December 5, 2016
BOARD OF COUNTY COMMISSIONERS
ORANGE COUNTY, FLORIDA
Addendum No. 4, IFB Y17-718-CC
DEPUTY JONATHAN "SCOTT" PINE COMMUNITY PARK

This addendum is hereby incorporated into the bid documents of the project referenced above. The following items are clarifications, corrections, additions, deletions and/or revisions to, and shall take precedence over, the original documents. Underlining indicates additions, deletions are indicated by ~~strikethrough~~.

A121

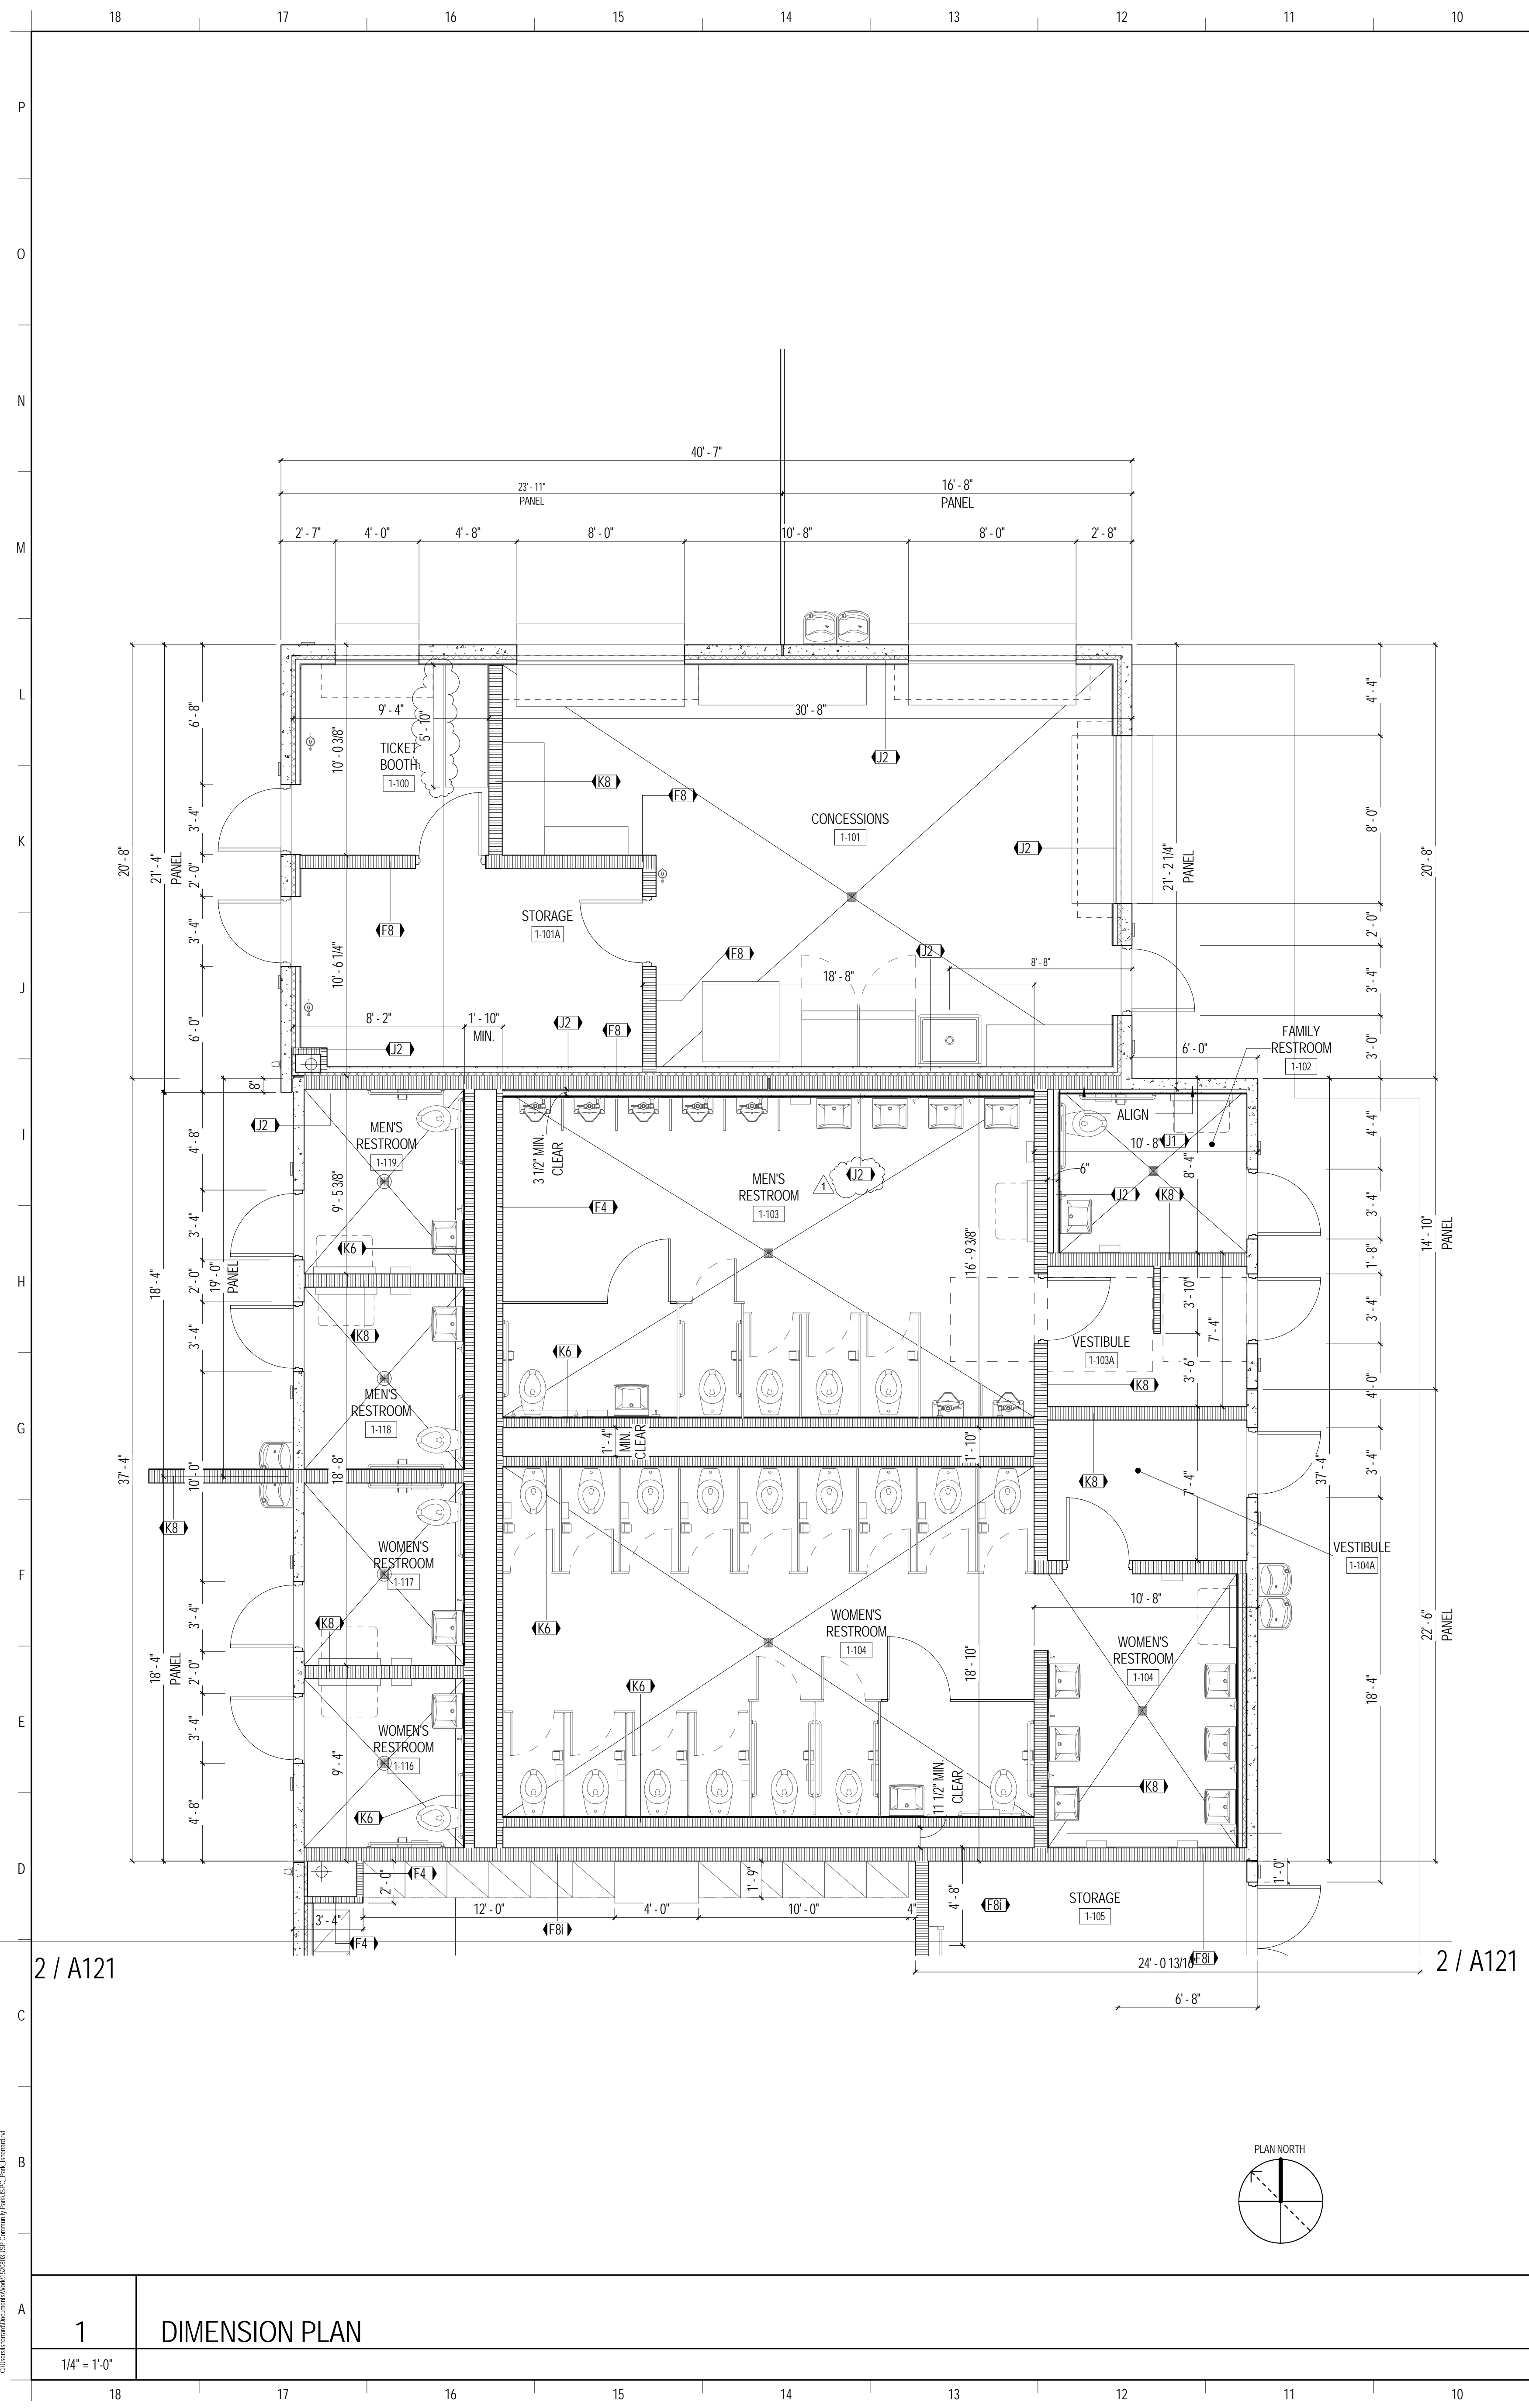
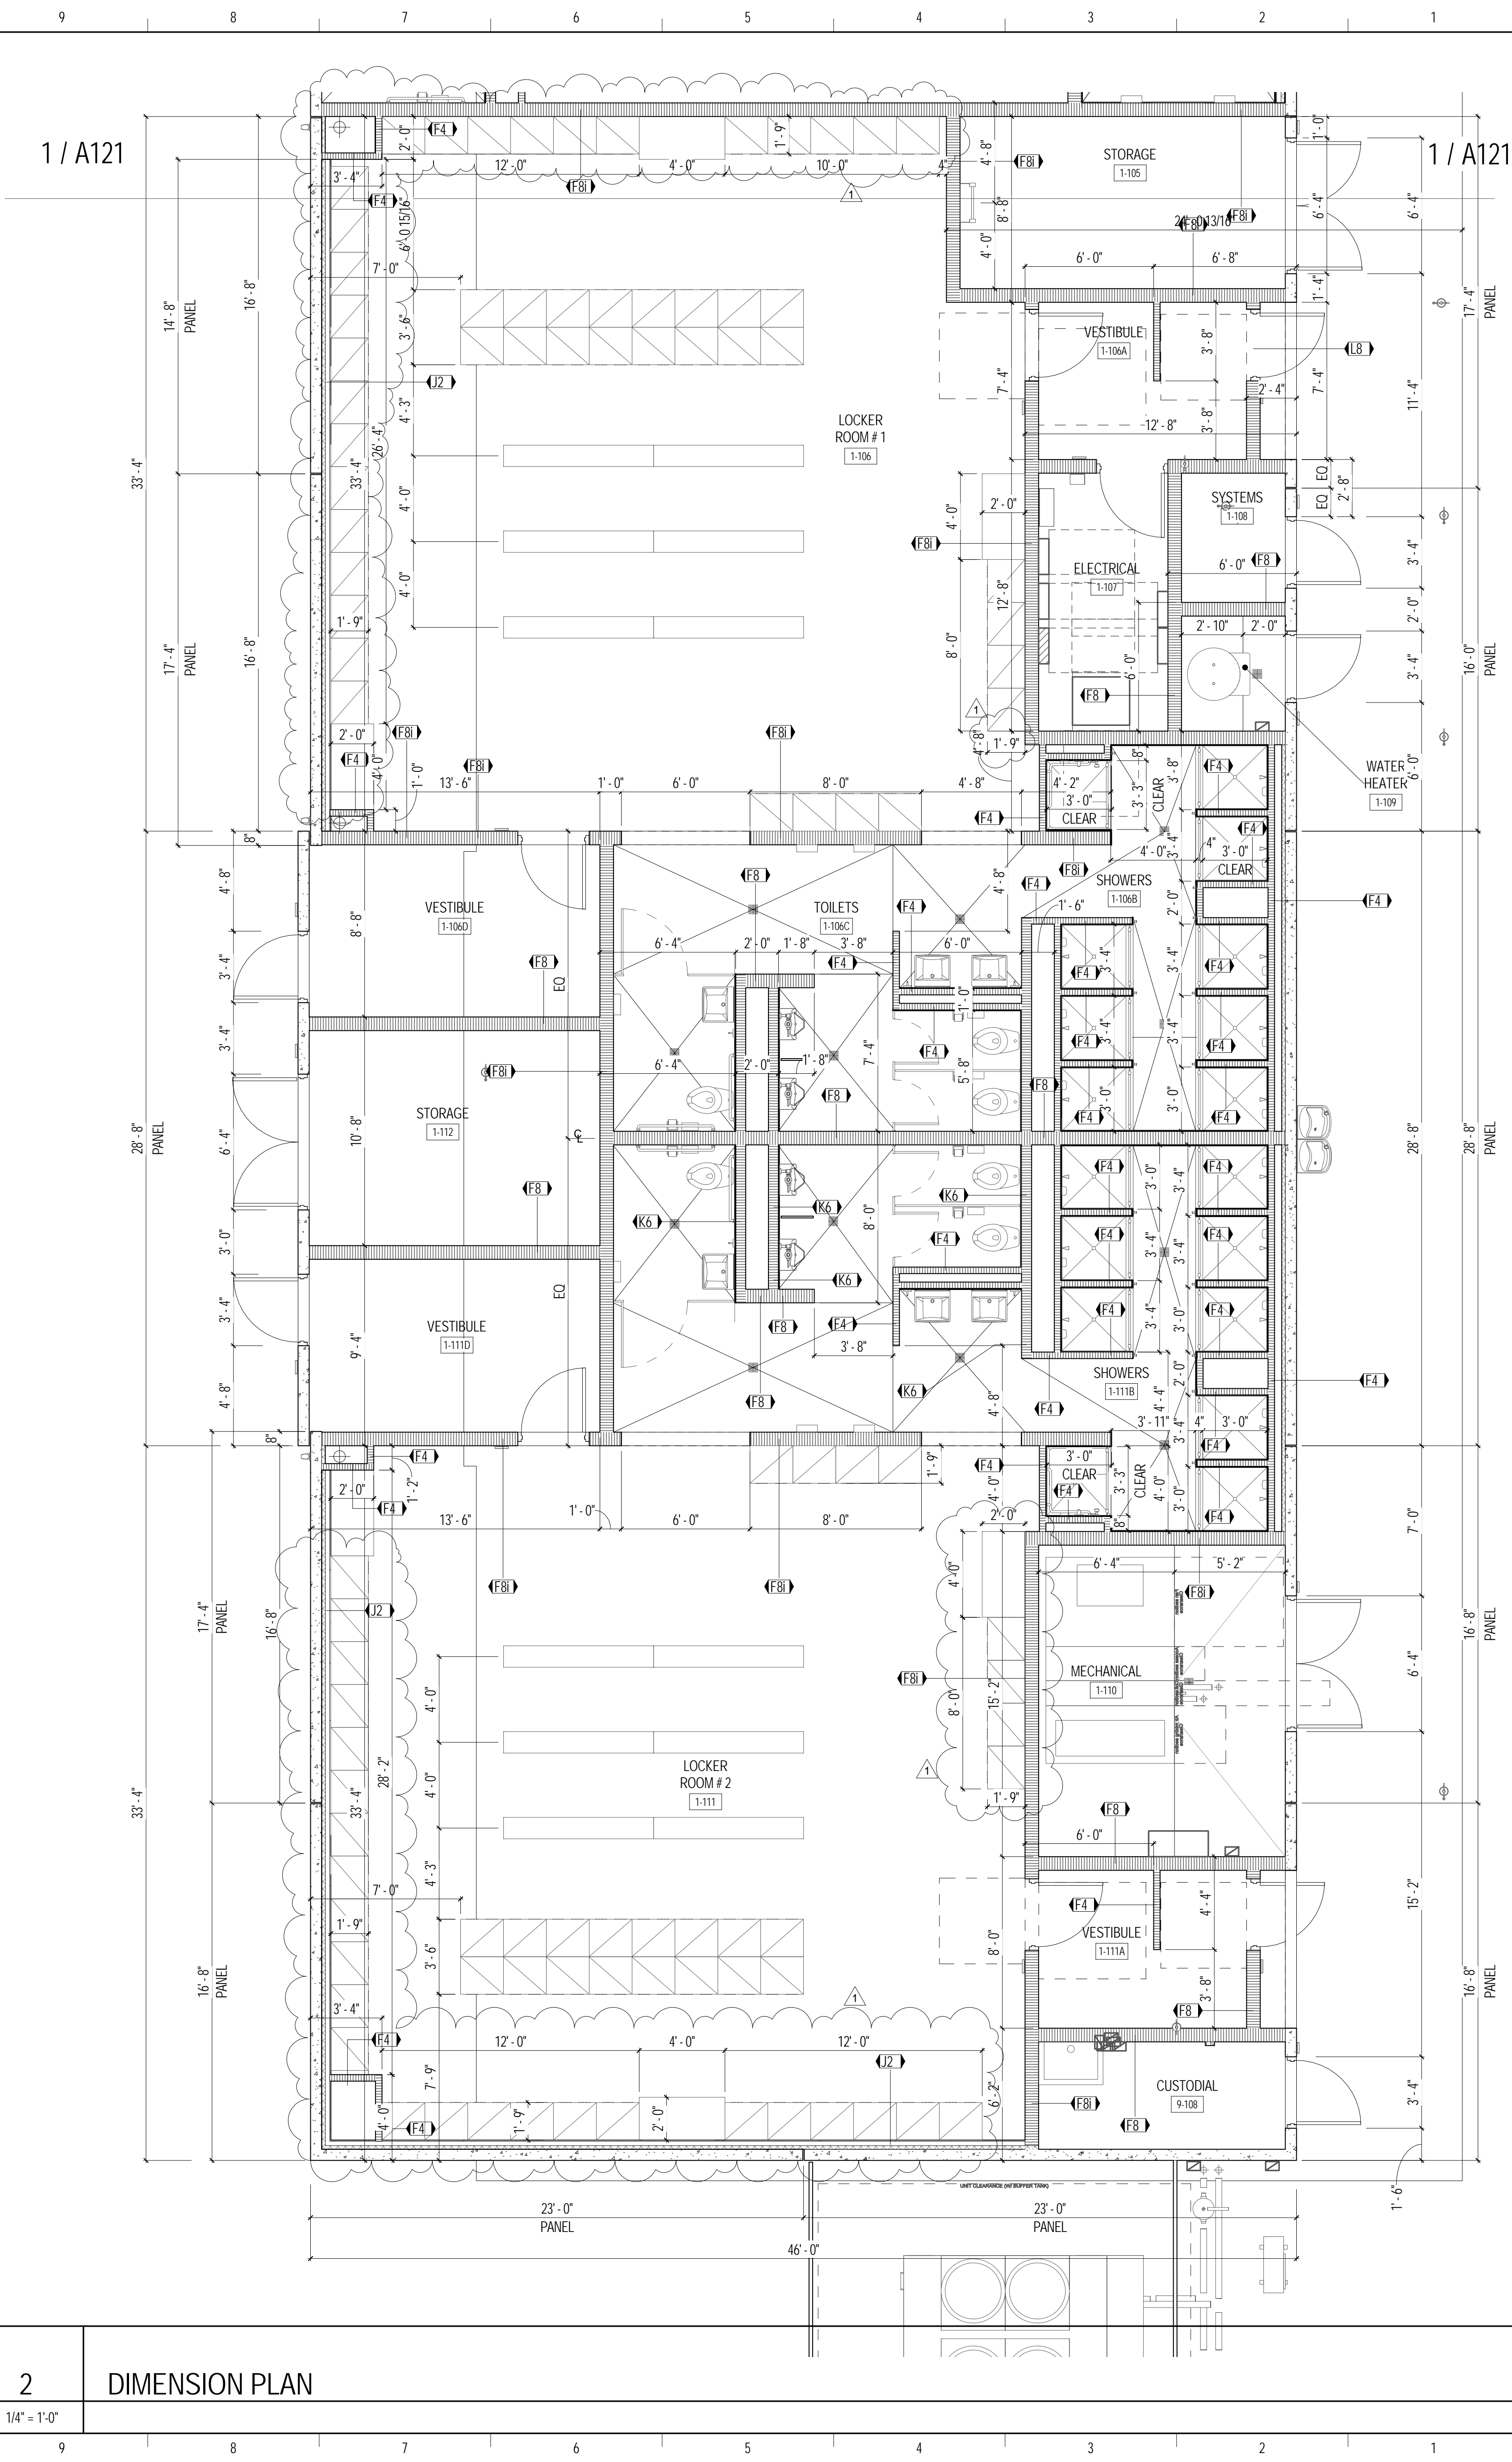
- b. DRAWING SHEET A121 – DIMENSION PLAN, dated 12/5/16
 - i. Dimensioned layout of locker rooms
 - c. DRAWING SHEET A901 – EXTERIOR DETAILS, dated 12/5/16
